May 26, 2017

TO : All Bidders
FROM : George M. Wiens
PROJECT : CTE Classroom Addition
1615400.41
SUBJECT : Addendum 1
DSA : 04-115755 / 33-H18

NTS 1

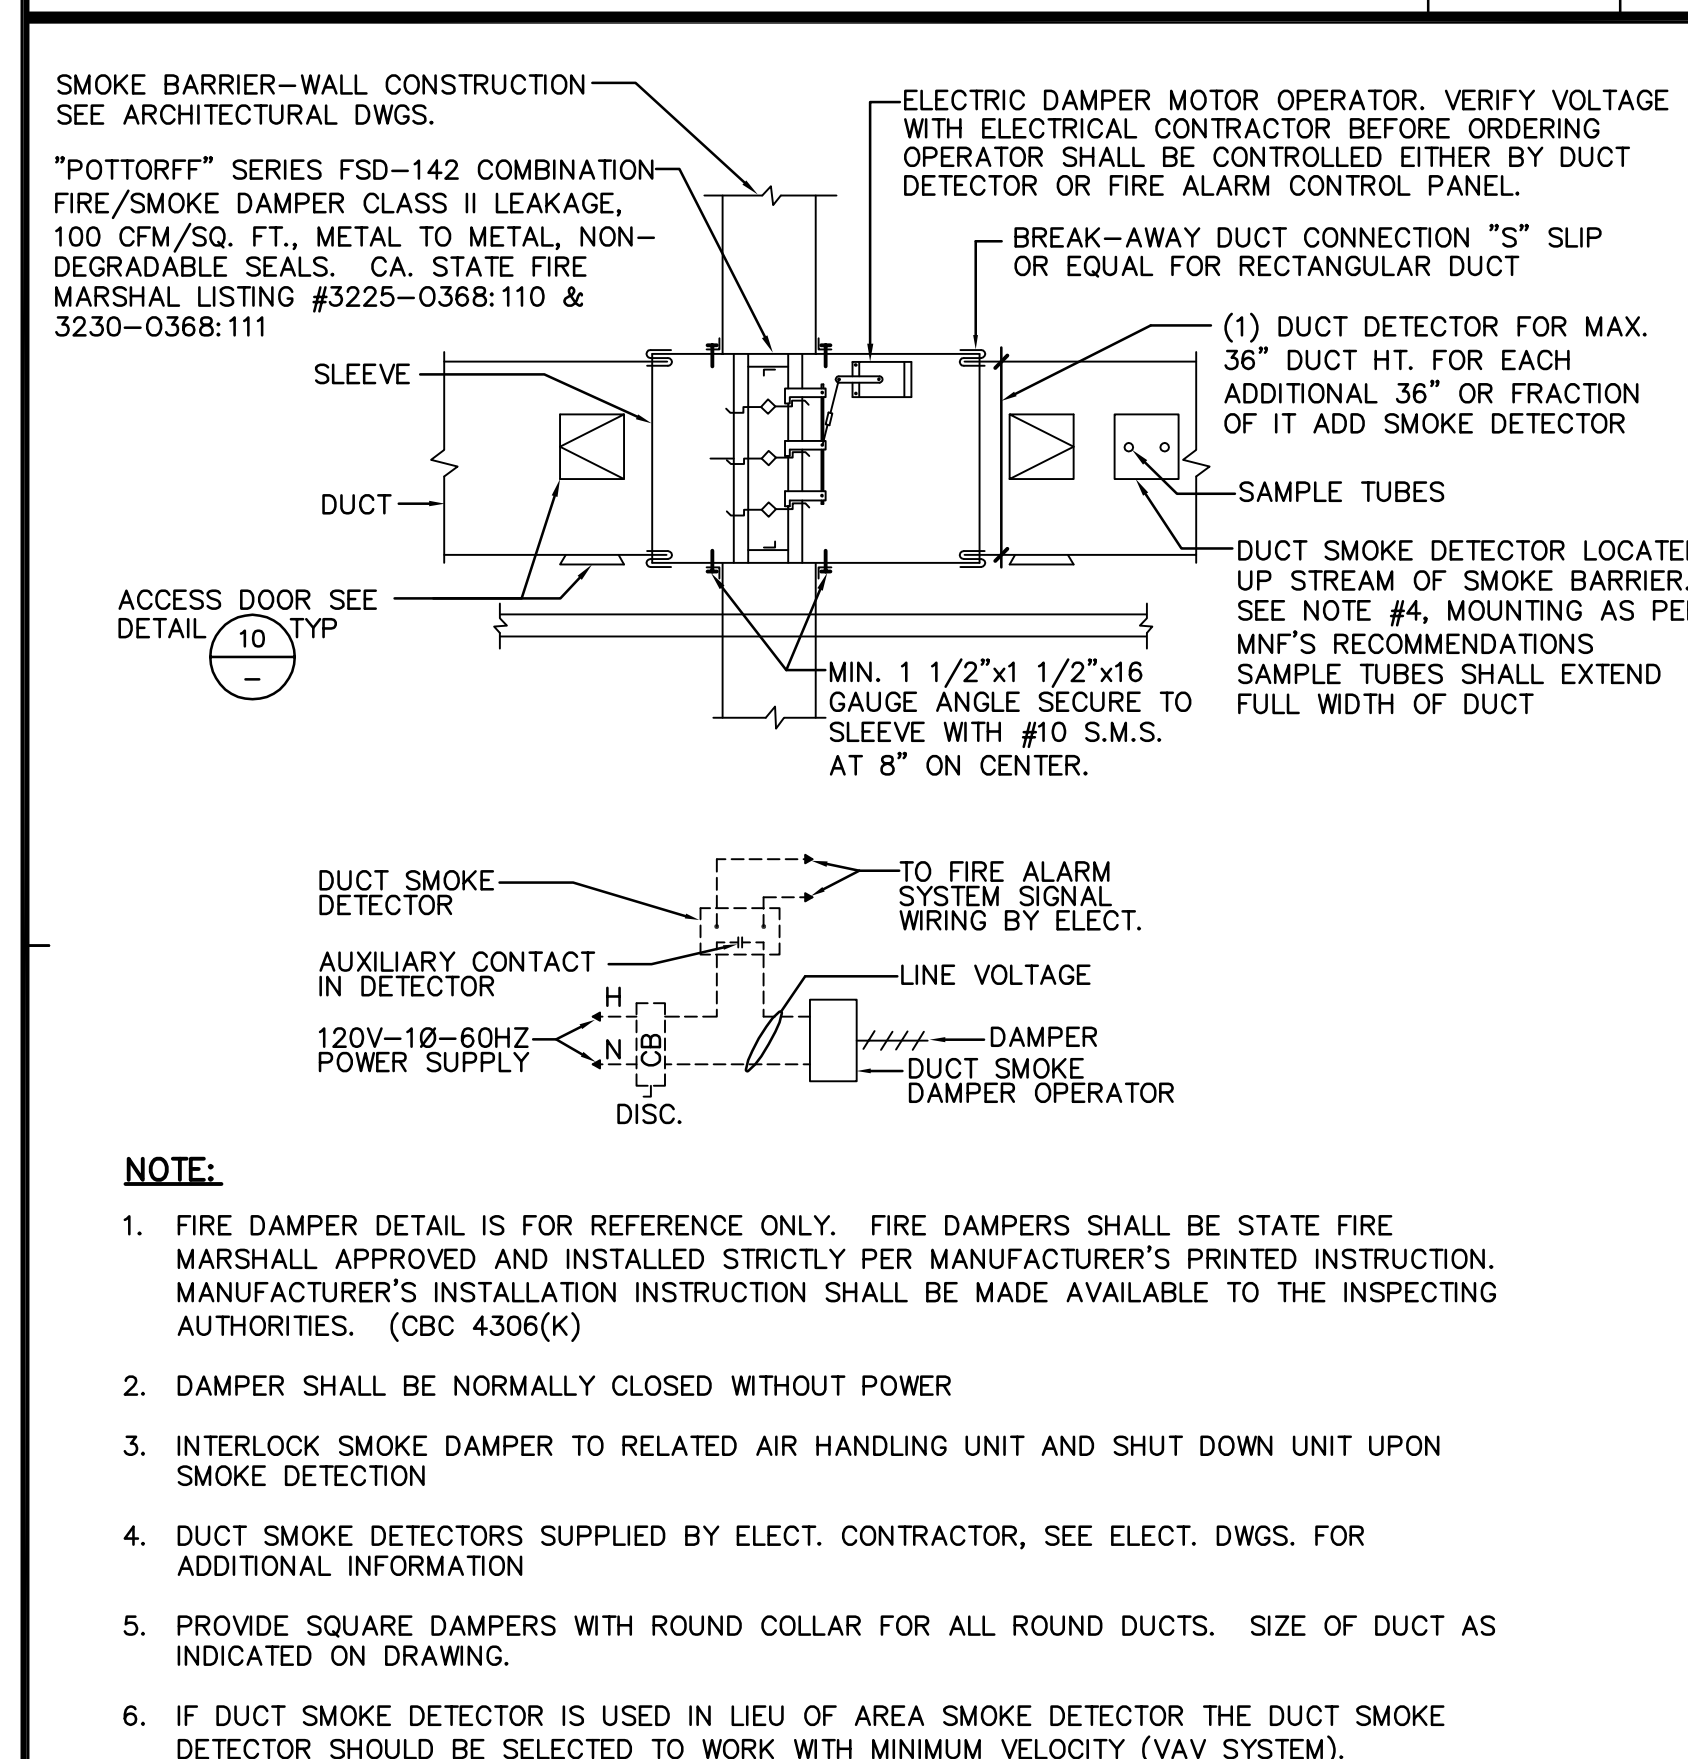
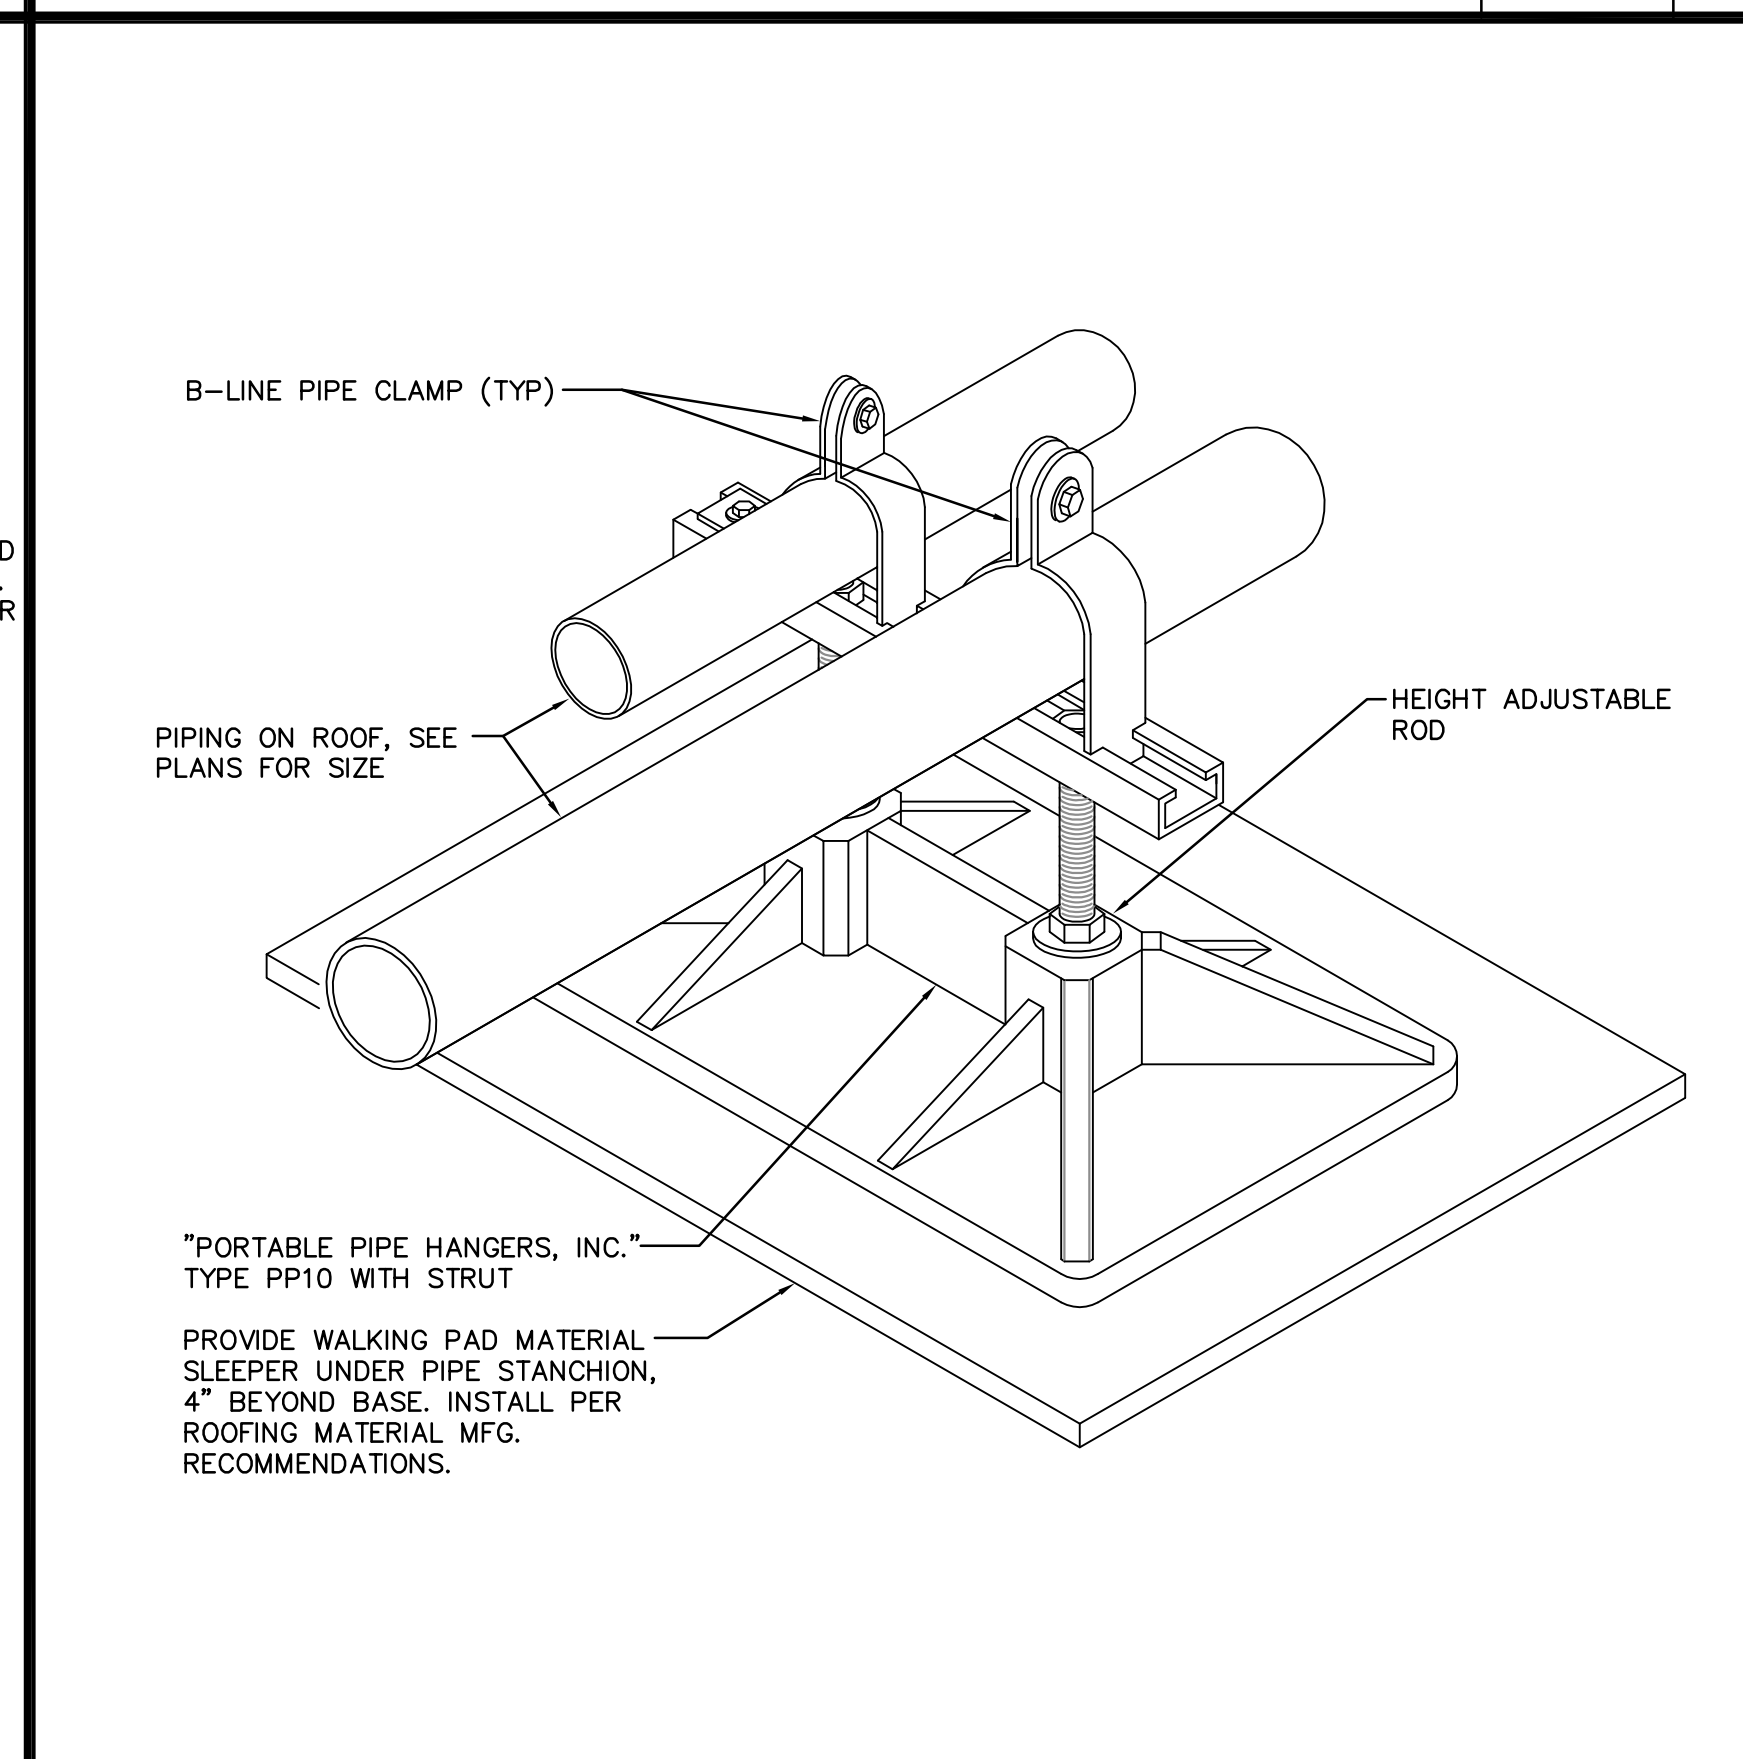
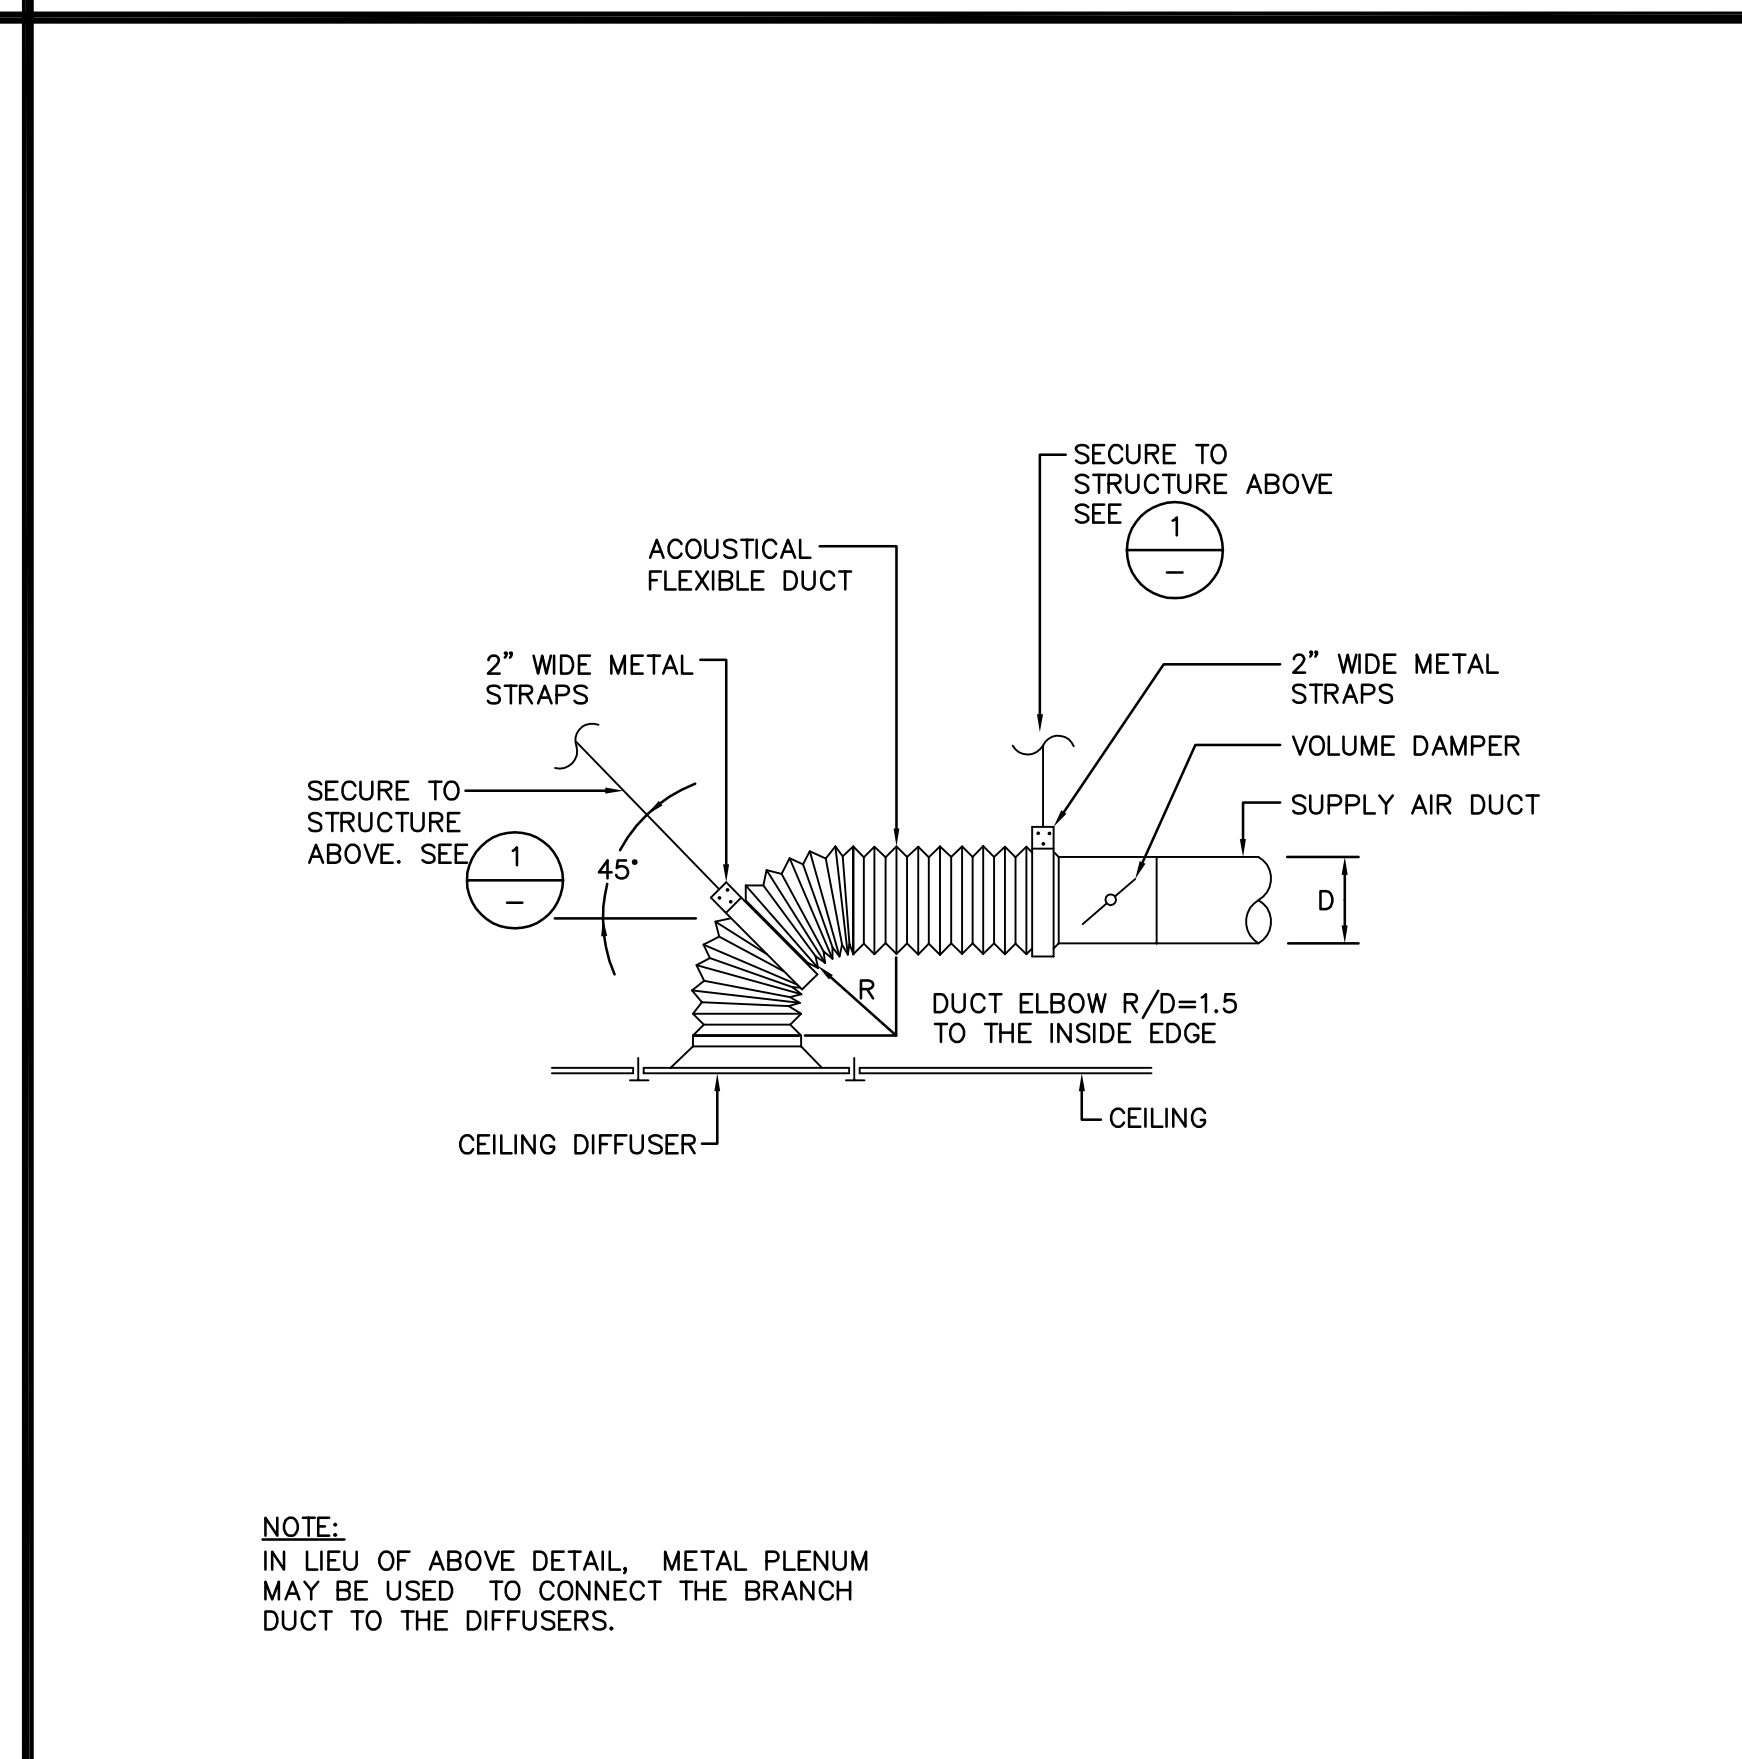
- A. Revise as indicated in the clouded area labeled Delta 1 on the attached M4.1.
